Initial Project Review

Preliminary Short Plat / Planned Development District / Environmental Checklist: Starkel Estates PDD

Application Numbers: 946944, 946945, 946946

Starkel PDD / Preliminary Plat Drawing

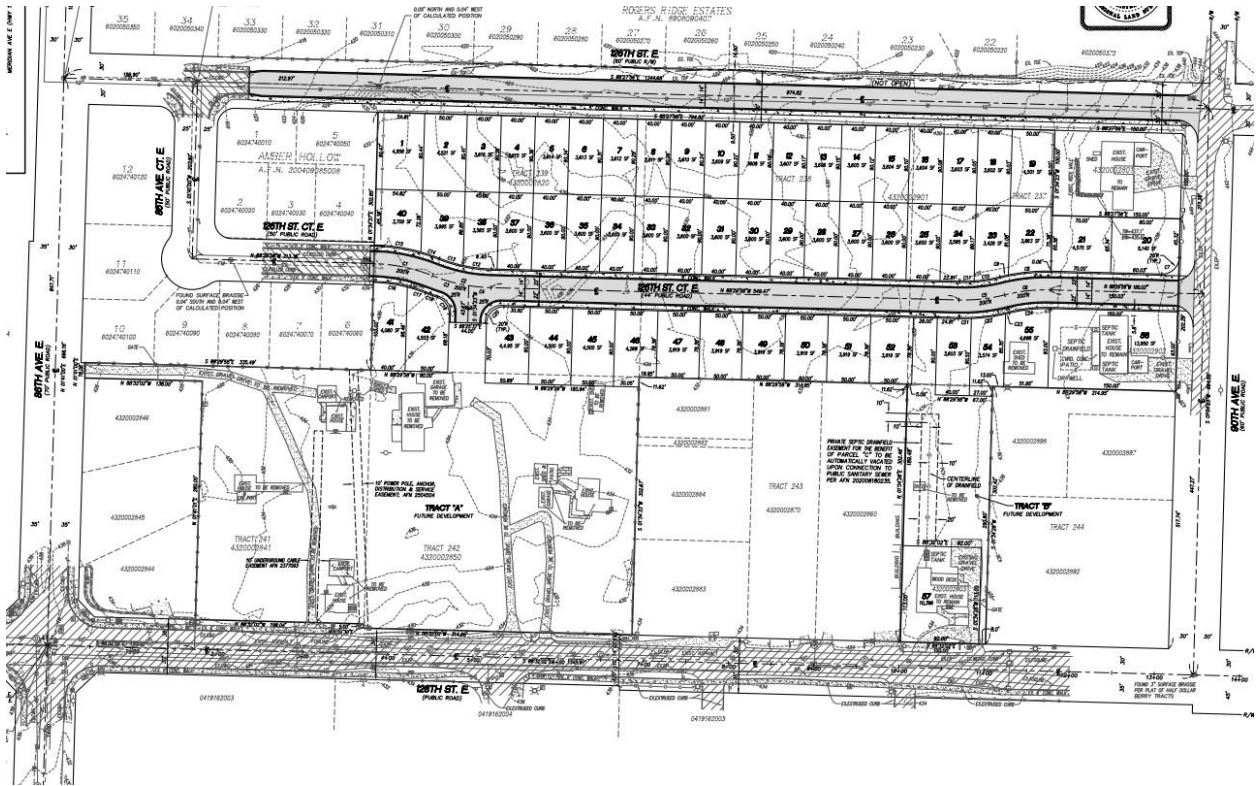
The TIA should be conducted by or under the direction of a registered professional engineer in the State of Washington whose primary area of expertise is traffic engineering/transportation planning. The engineer should preferably belong to the Institute of Transportation Engineers (ITE) and have some experience in assessing development transportation impacts. Prior to submittal of the TIA, the applicant or his representative traffic engineer should contact the Traffic Division of Pierce County Public Works and Utilities and develop a scope of the TIA prior to actual submittal of the TIA. Traffic Engineering provided preliminary comments and have indicated Lot 57 needs to access from the internal plat roads and not from 128th St. E.

- A Public Road Variance/Deviation is required for a four-way local road intersection. See the Manual on Design Guidelines and Specification for Road and Bridge Construction in Pierce County Section 5-3.1 for requirements.

- Development Engineering also requested right-of-way be dedeed to bring the existing right-of-way up to the standard width. A five (5) foot strip of right-of-way is required along the project’s frontage with 128th Street East (abutting parcels 4320002850, 4320002901 & 4320002903).

Staff Comment: The applicants propose to reduce the minimum lot size and minimum lot width for the majority of the land division's new lots. The applicant states that the PDD approval will have a beneficial effect on the area by providing housing stock to the area. This will need to be clarified, and tangible effects on the community will need to be met as zoning in the area offers housing density at higher levels. Things such as recreational amenities, road or pedestrian improvements, and permanent open space have not been identified on the survey either that would indicate an increase in benefit to the area.

Infill Compatibility (18J.15.060): The southern boundary of Lots 49-52, the southeast corner of Lot 54, and the southern boundary of Lot 55 will need to meet the following requirements:

These areas have not been identified on the plat drawing, only the future development tracts.
